ARCHITECTURAL CONTROL COMMITTEE
SANDY BAY HIGHLANDS SUBDIVISION NO. 2

PLAN REVIEW CHECKLIST

Legal Description LT 7 Blk 4 SBH No. 2

THE PETERSON RESIDENCE
LOT #7 LAKE BREEZE WAY, TWO RIVERS

Site Plan

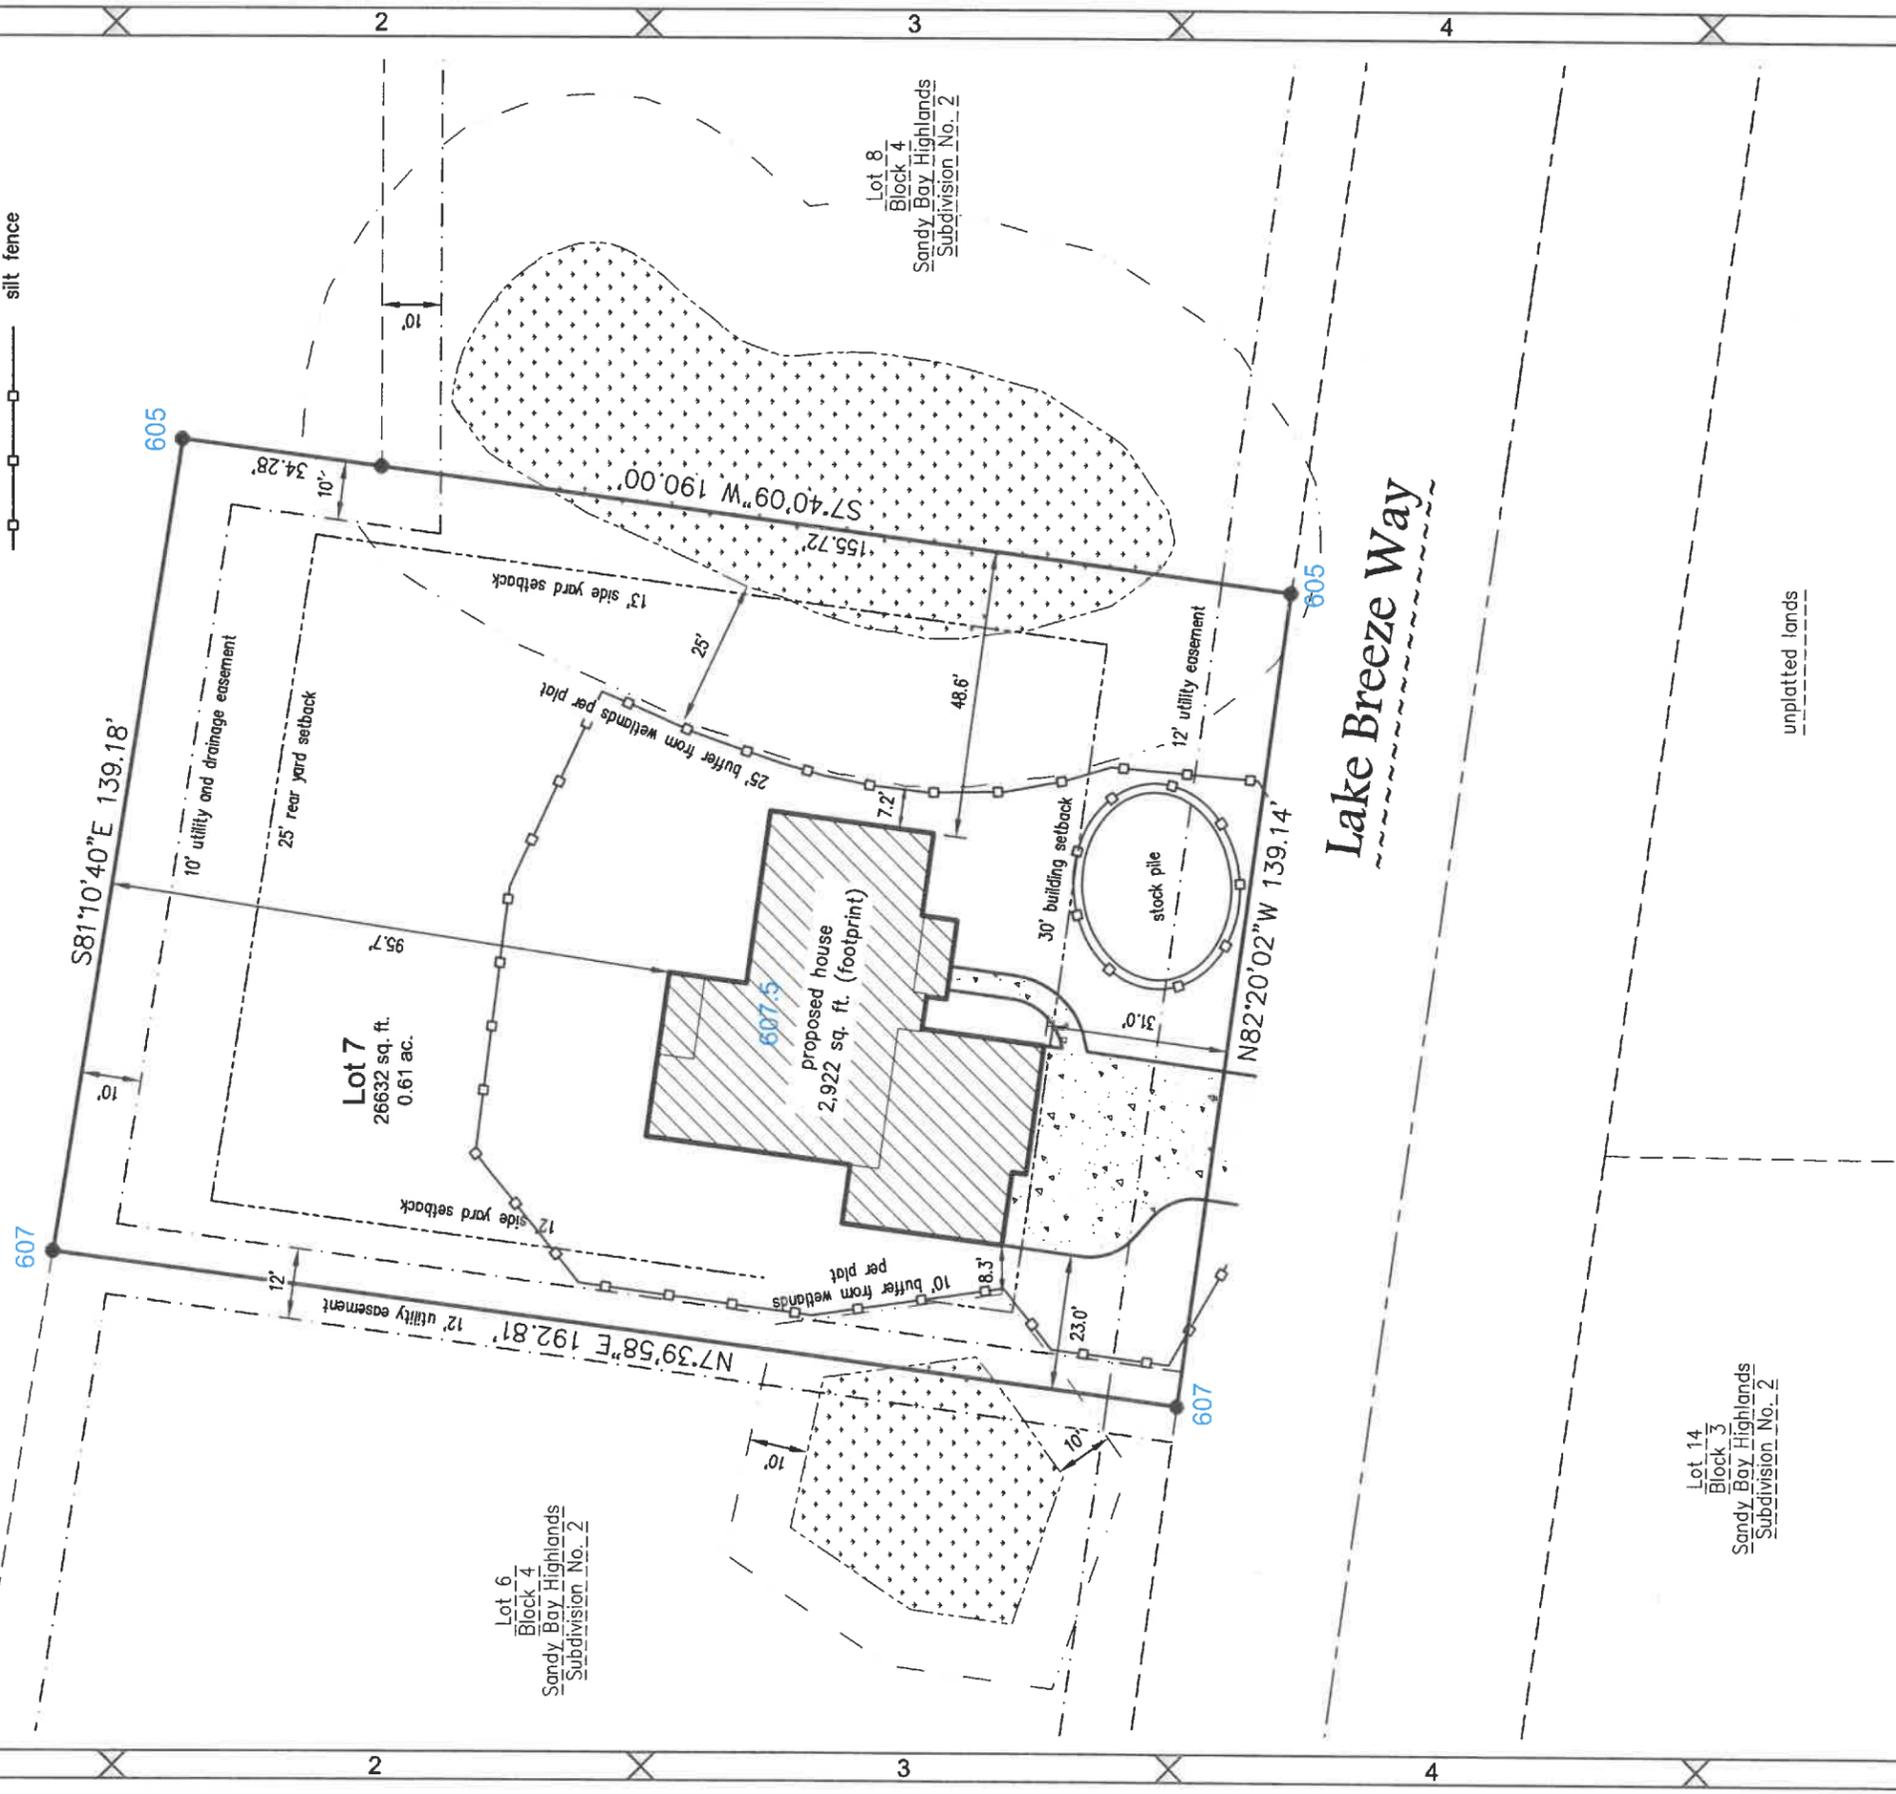
- Site Plan (to scale) *missing elevations*
- Grading Plan (to scale)
- Elevations (4 elevations - color schematic)
- Floor Plan (including sq ft for each level of dwelling)

Sump Pump must connect to public storm sewer
not shown on plan
